CASE #PL2020-69

## MEMORANDUM

**Date:** March 25, 2020  
**To:** Brian Hansen  
**From:** Bryan T. Nemeth, P.E., PTOE  
Kelsey. E. Retherford, P.E.  
**Subject:** Village Club Parking Study  
City of Bloomington  
Project No.: T44.119241

**Figure 6. Parking Distribution Throughout Proposed Site**

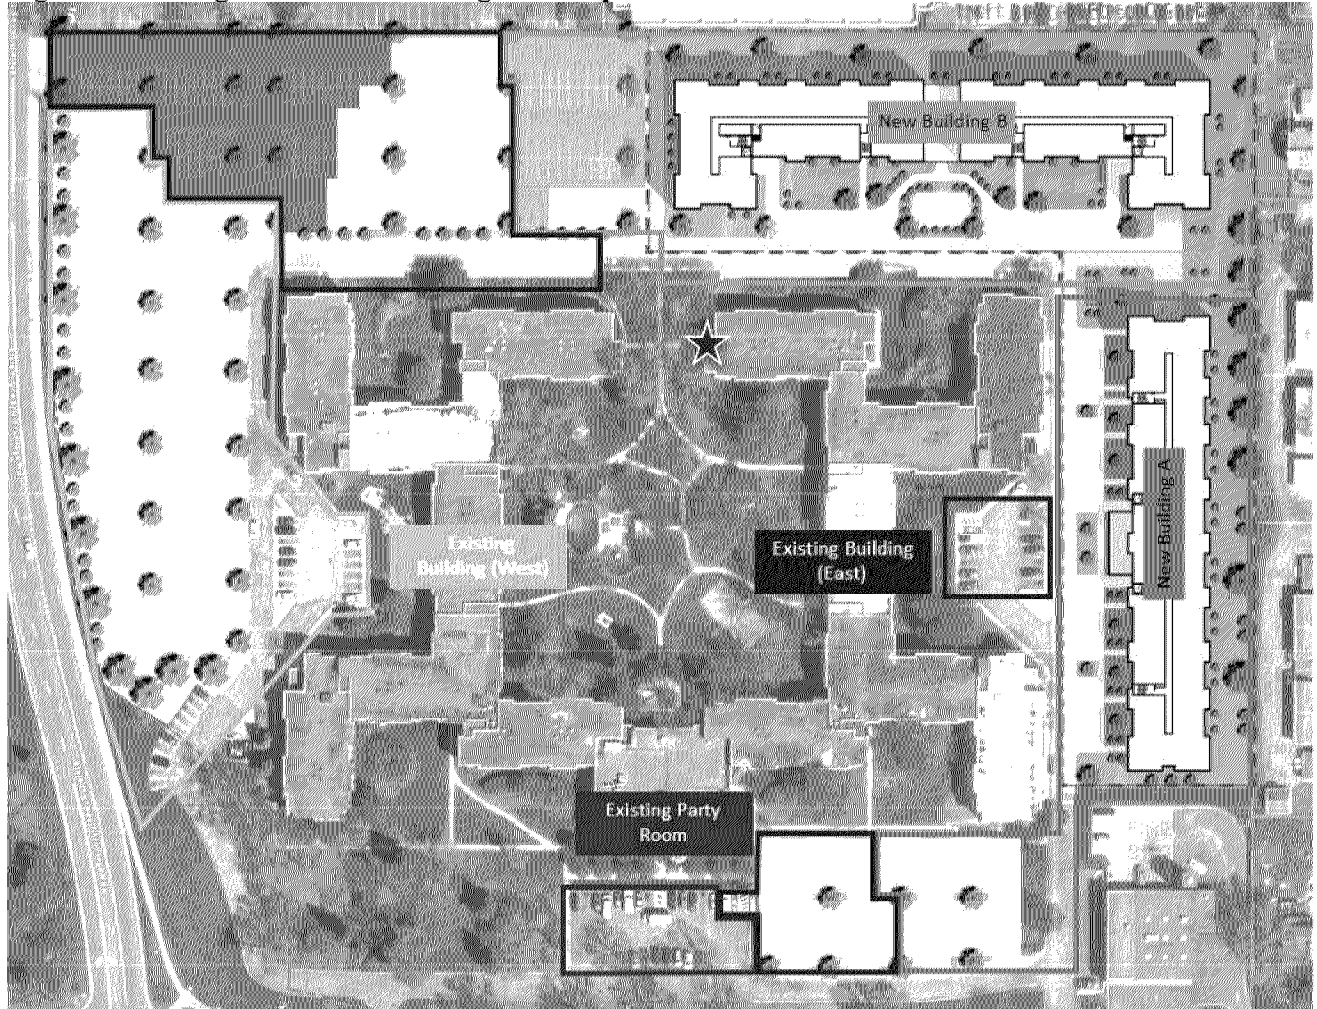
As the code states, the 400 ft is to be measured from the buildings main entrance. The main entrance was used as a reference point for the two new buildings however, since the existing building is larger and more spread out, the 400 ft was measured from the building access that was nearest to the parking lot area in question. For example, the parking in the northwest corner boxed in blue assumed to be for residents in the eastern portion of the existing building was measured from the building entrance denoted with a star on **Figure 6** below. **Figure 6** shows show the parking stalls assumed to be associated with each building and shades the spots that are more than 400 ft away from the buildings access point.

**Table 4** summarizes the total required parking at each building accounting for the 29.5% deviation as proposed by Aeon, the parking stalls determined to be within 400 ft of the building, and how many

parking spots are located more than 400 ft away. **Table 4** indicates that the New Building B and Existing Building (East) have 45 and 78 spots respectively that are further than 400 ft away.

In order to mitigate this issue, it is recommended that Aeon shift the location of New Building B from the northeast corner to the northwest corner of the property. This would allow parking for residents in the eastern portion of the existing building to park where the current New Building B is shown which is within 400 ft of a building access point. Also, with the New Building B built in the northwest corner of the property there will be parking stalls directly south of the building which will also be within 400 ft of the buildings main access, meeting City Code. If these modifications are not made residents may choose to park in the adjacent properties parking lots which could cause parking shortages for the residents of these other properties.

While reviewing the proposed parking configuration another item of concern was the placement of the compact parking stalls. All of the compact parking was shown along the northern edge of the site. It is recommended that this parking be moved closer to the existing/proposed buildings as this will ensure an increased number of parking stalls within 400 ft of the building access points. Additionally, the further parking spots are typically filled last. Having the compact parking spaces furthest from the buildings will likely result in larger vehicles using more than one space each, further putting a strain on the total parking spaces available for use.

Additionally, in order to accommodate emergency vehicles throughout the site it is recommended that “No Parking” signs be installed in tight areas such as the northeast corner of the existing building.

Based on the review of the proposed parking lot configuration it was determined that the current layout does not provide parking for all residents within 400 ft of the building as required by City Code. The location of New Building B should be relocated the northwest corner of the site in order to meet the City Code requirement.

All compact vehicle parking spaces should be relocated closest to the building to increase the number of spaces closest to the buildings and to ensure that larger vehicles do not use them.

Relocate New Building B to the northwest corner of the site in order to meet the City Code requirement. Parking stalls shall be assigned to ensure stalls are located within 400 ft each residents' respective building and compact parking stalls should be moved closer to the apartment buildings. Install "No Parking" signs where necessary in tight areas to ensure emergency vehicles can navigate the site. Additional parking stalls are recommended if parking stalls will be used to accommodate snow storage.
